SVS-01-13  
1/16/2013

**Service &  
Parts  
Bulletin**

**SUBJECT: ALL 4HK1X ENGINE THERMOSTAT PARTS CHANGE AND INSTALLATION PROCEDURE**

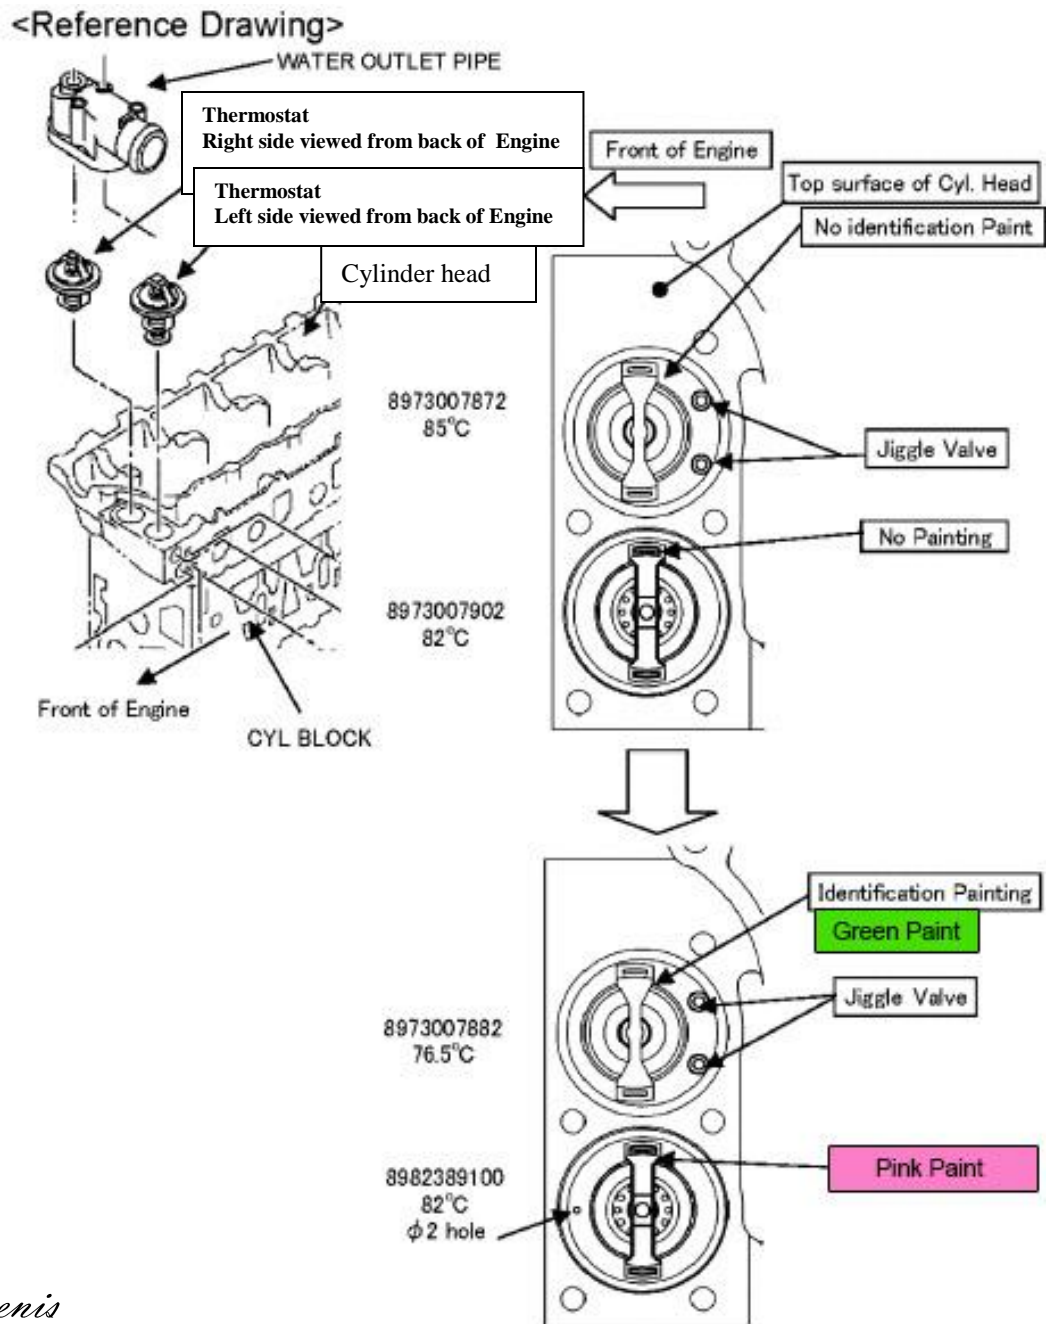
Isuzu Motors America, LLC PowerTrain Division (ISZAPT) has implemented a thermostat change on the 4HK1X engines due to parts commonization and improvement of air venting. Opening valve temperatures will be changed and a water drain hole has been added. This bulletin covers the procedure to identify and properly install the updated thermostats. Please refer to the attached pictures noting the green and pink paint dots on the new thermostats and the proper placement of these thermostats in the engine. This thermostat parts change will be implemented in production engines February 2013.

Side	Reference	Current	New
Right Side (viewed from back of engine)	P/N	897300 7872	897300 7882
	Opening Valve Temp	85 Deg C	76.5 Deg C
	Water Drainage Hole	Jiggle Valve*2	Jiggle Valve*2
	Identification Paint	Nothing	Green
Left Side (viewed from back of engine)	P/N	897300 7902	898238 9100
	Opening Valve Temp	82 Deg C	82 Deg C
	Water Drainage Hole	Nothing	2 Dia
	Identification Paint	Nothing	Pink
